ZONING CHANGE REVIEW SHEET

CASE: C14-2010-0015 (The Domain Rezoning-Endeavor) **P. C. DATE:** August 10, 2010

**MEMORANDUM**

SUBJECT: C14-2010-0015 (Endeavor Domain)

Shared Lane Marking

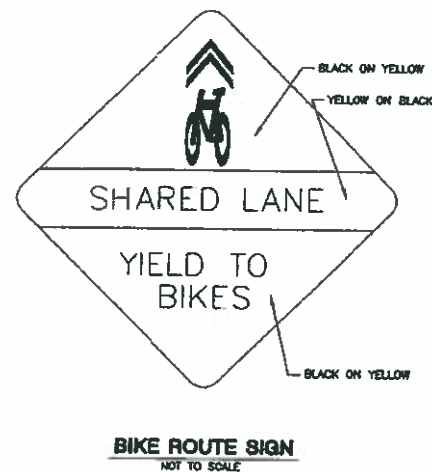
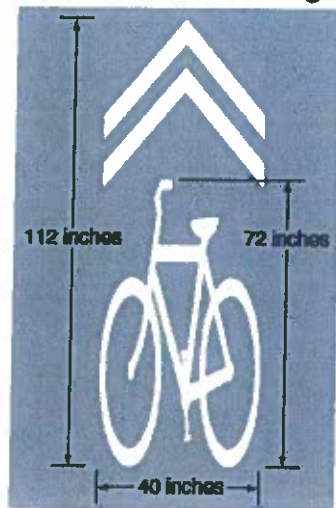
1. Provide bicycle facilities for the project by routing shared lane markings (sharrows) and multi-use (hike and bike) trails through the project as detailed in the attached exhibit, and in compliance with the following standards:

Sharrows

- Shared lane markings shall be installed on roadways shown as sharrow routes on the attached exhibit. The shared lane markings shall be placed with the tip of the chevron in the middle of the lane as measured from face of curb.
- A sharrow facility sign as shown below at a size no smaller than currently installed by Simon on Kramer Ln. shall be placed at least 2 per block (one on each side of the street)
- Angled and head in parking prohibited on either side of roads with required sharrows. Reverse angled parking is acceptable.
- Shared lane markings (sharrows) shall be installed within one year of this agreement on existing roadways and installed at the same time as new roadways are constructed.
